MINISTRY OF TRANSPORTATION AND COMMUNICATIONS ONTARIO			
KINGSTON	J.D. LEE ENGINEERING LIMITED CONSULTING ENGINEERS	BRANTFORD	
MYER CAVE BRIDGE (5.1 MILES EAST OF HWY. NO. 41)			
KING'S HIGHWAY No. 506		DIST. No. 10	
CO. FRONTENAC		LOT 23 CON. VIII	
GENERAL LAYOUT			
APPROVED	STRUCTURAL ENGINEER	CONTRACT No.	
DESIGN	A.Z.	CHECK	D.M.N.
DRAWING	T.L.	CHECK	P.M.N.
DATE	JULY 75	LOADING	4520-44
SITE No. 7-2		SHEET 1

FOUNDATION INVESTIGATION REPORT

The Proposed Structure at the Crossing of
Revised Hwy. #506 (Line 'M') and
Marble Lake and Georgia Lake
Township of Barrie, County of Frontenac
District No. 10 (Bancroft)
W.O. 71-11119 - W.P. 110-65-00

Myer Cave Bridge
W.P. # 110-65-00 Site # 7-2
Highway # 506 District # 10

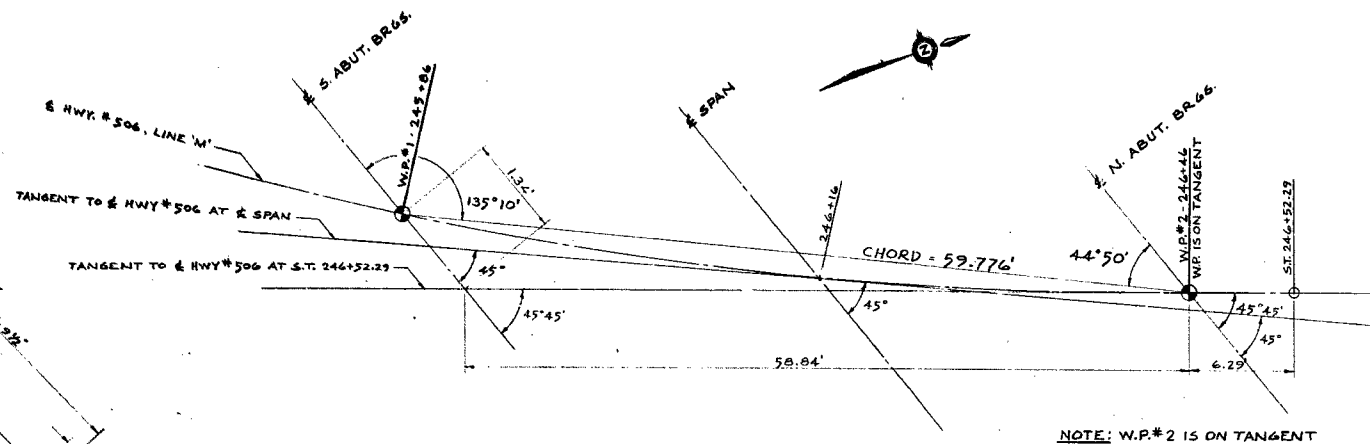
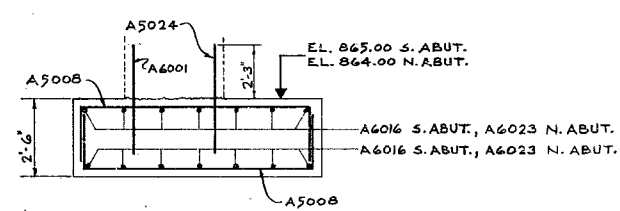
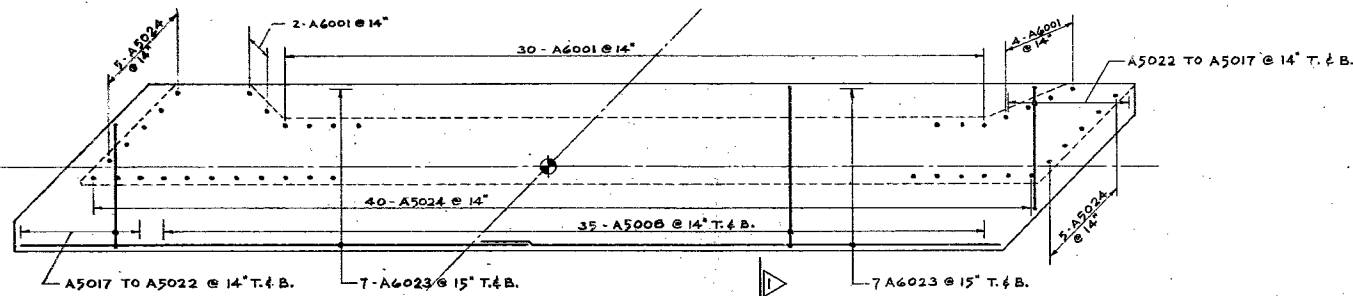
Attached herewith we are submitting the final bridge
drawings which show the foundation design for this structure.
Kindly give us your comments at your earliest convenience.

*P.s. → Footings will be located below channel water level and some
clearing may still be necessary for the correct location of foundation*
